5 December 2023
MES/2312/TER284

Ref: Rosedale College, Hayes – Addendum Flood Risk Assessment (Groundwater)

Further to your instruction, we have reviewed the HSP Flood Risk Assessment (FRA) (ref: HSP2022-C3886-C&S-FRAS1-536, 11 April 2022, Revision A, Final) with regard to Rosedale College, Hayes, UB3 2EL (the site, Figure 1) and the following query raised by the Lead Local Flood Authority (LLFA) as part of a Planning Consultation with the London Borough (LB) of Hillingdon for the proposed development of additional educational facilities at the site:

Figure 2: LB Hillingdon SFRA, Susceptibility to Groundwater Flooding

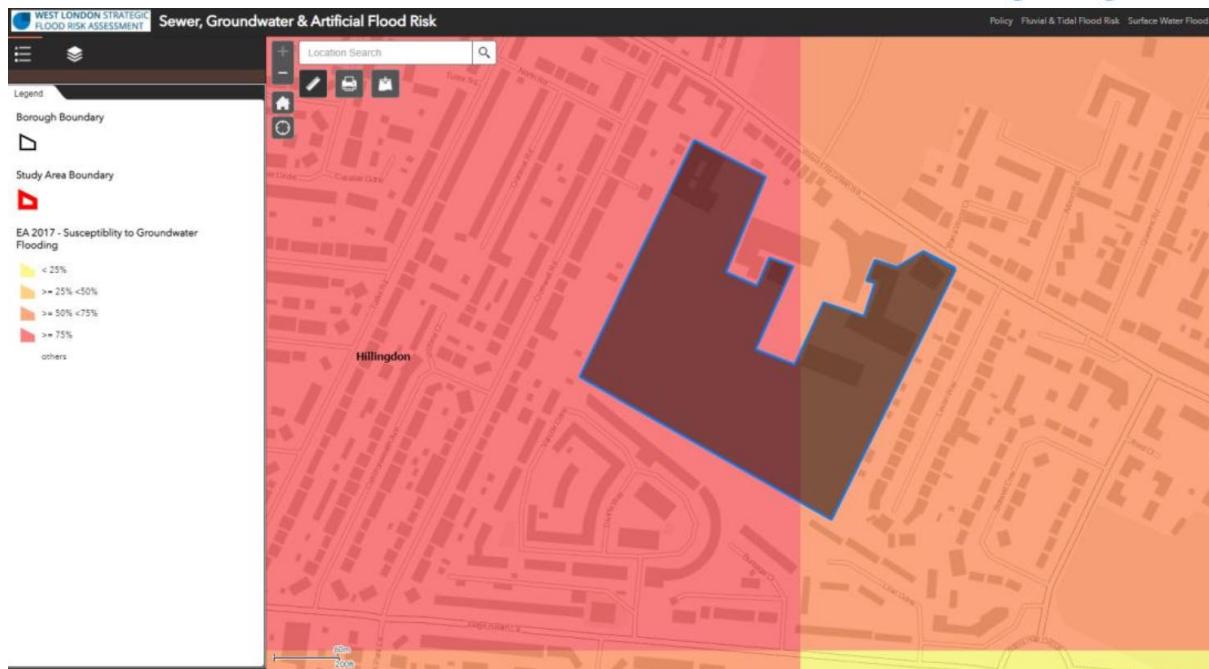
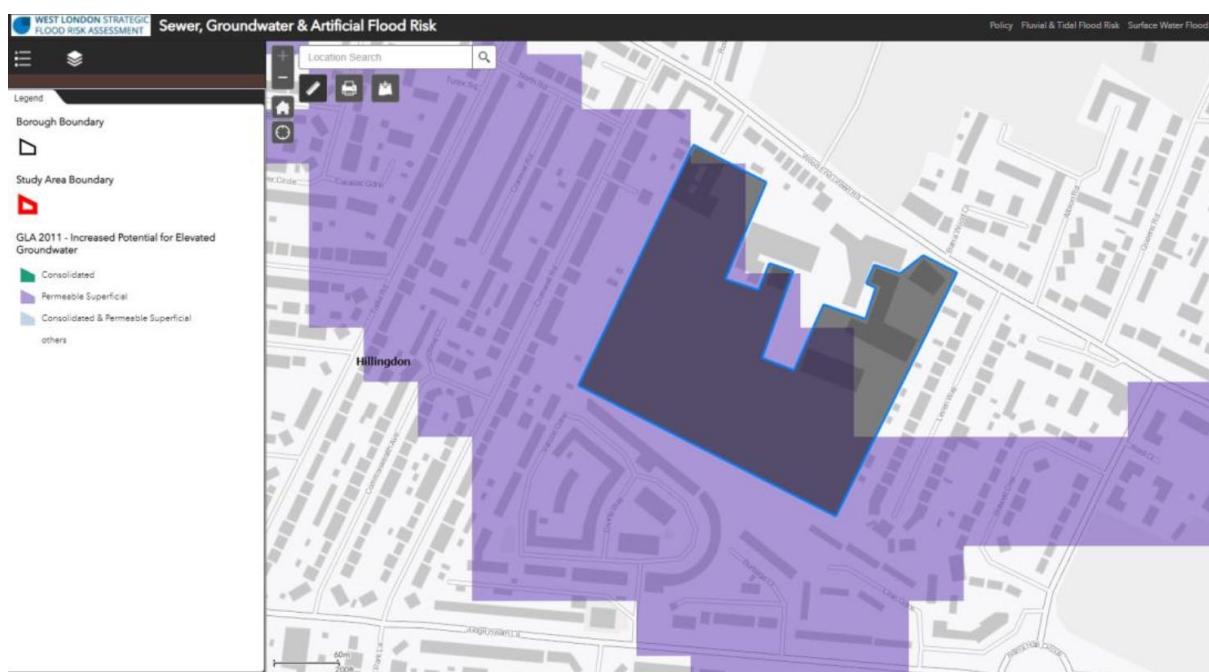
- a) Section 12.3.1 (page 27 of the digital pdf report, as referenced in the LLFA query) states: *'According to the researched mapping from the SFRA, the site is located in an area which is considered to be susceptible to groundwater emergence (Figure 2), with the potential for an elevated water table across the site (Figure 3).'*

b) Section 12.3.2 states: *'Given that there have been recorded incidents of groundwater flooding across the site, the risk of groundwater/clearwater flooding may be significant and it is possible that mitigation/management will be required.'*

c) However, section 5.2.4.1 advises that: *'There have been no groundwater flooding incidents between December 2011 to June 2017'*.

e) It seems likely that the statement in 12.3.2 has been made in error and that the statement in 5.2.4.1 is correct (as there is no evidence in the FRA or SWMP to support 12.3.2).

f) The recommended site investigation would therefore appear to be reasonable in order to address the SFRA mapping (as 12.3.1).

Figure 4: LB Hillingdon SWMP of Groundwater Flood Incidents

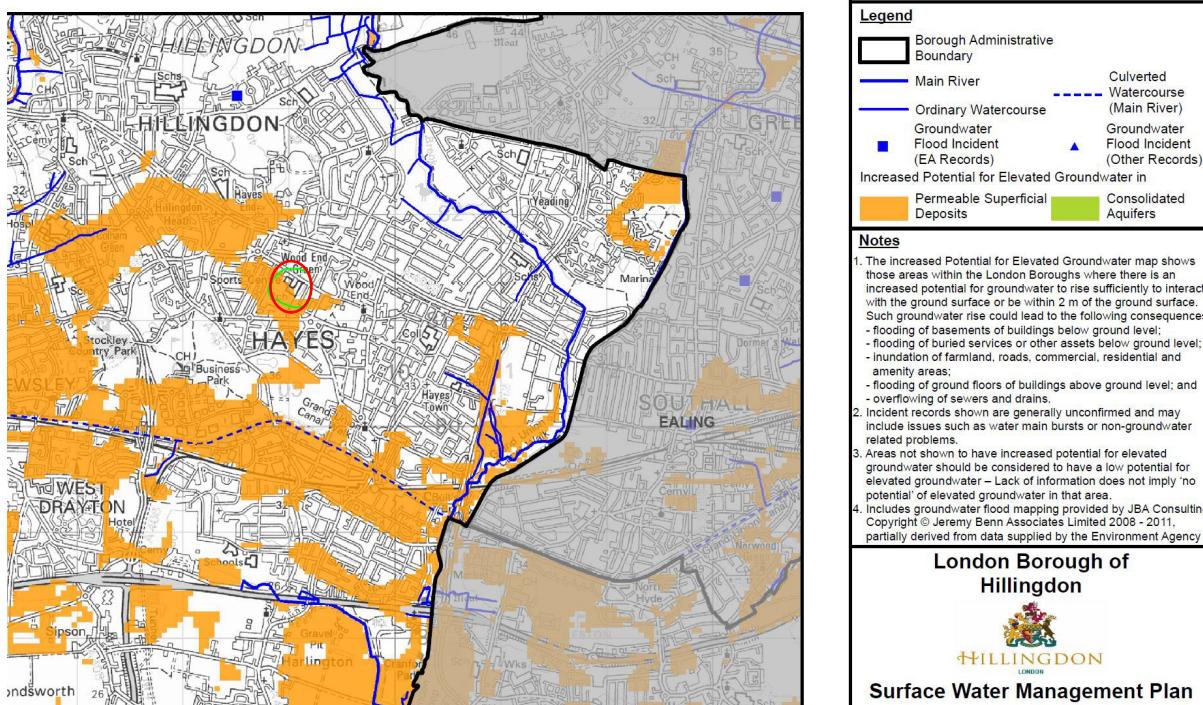
d) There are no other references to groundwater flooding incidents in the FRA and the LB Hillingdon Surface Water Management Plan (SWMP) (Figure 4) does not show flood incidents at the site location.
